Form 3160-5
(August 2007)UNITED STATES
DEPARTMENT OF THE INTERIOR
BUREAU OF LAND MANAGEMENTFORM APPROVED
OMB No. 1004-0137
Expires: July 31, 2010**SUNDRY NOTICES AND REPORTS ON WELLS**
*Do not use this form for proposals to drill or to re-enter an abandoned well. Use Form 3160-3 (APD) for such proposals.*5. Lease Serial No.
NM-89879

☒ Oil Well ☐ Gas Well ☐ Other8. Well Name and No.
SHUGART B #22. Name of Operator
Hudson Oil Company of Texas9. API Well No.
30-015-055533a. Address
616 Texas Street
Ft. Worth, TX 76102

13. Describe Proposed or Completed Operation: Clearly state all pertinent details, including estimated starting date of any proposed work and approximate duration thereof. If the proposal is to deepen directionally or recompleate horizontally, give subsurface locations and measured and true vertical depths of all pertinent markers and zones. Attach the Bond under which the work will be performed or provide the Bond No. on file with BLM/BIA. Required subsequent reports must be filed within 30 days following completion of the involved operations. If the operation results in a multiple completion or recompleation in a new interval, a Form 3160-4 must be filed once testing

Proposed Wellbore

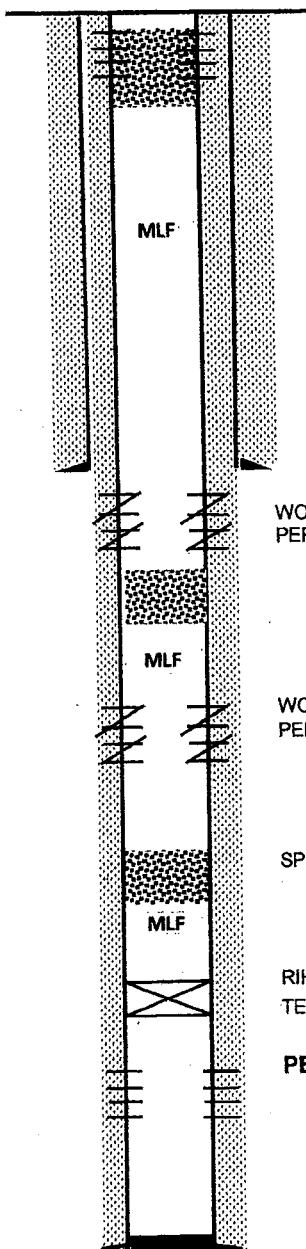
* Set 2nd CIBP above perfs @ 3362 - 3374. (3262) cap w/ 25 sx cmt.

Below ground level dry hole marker required
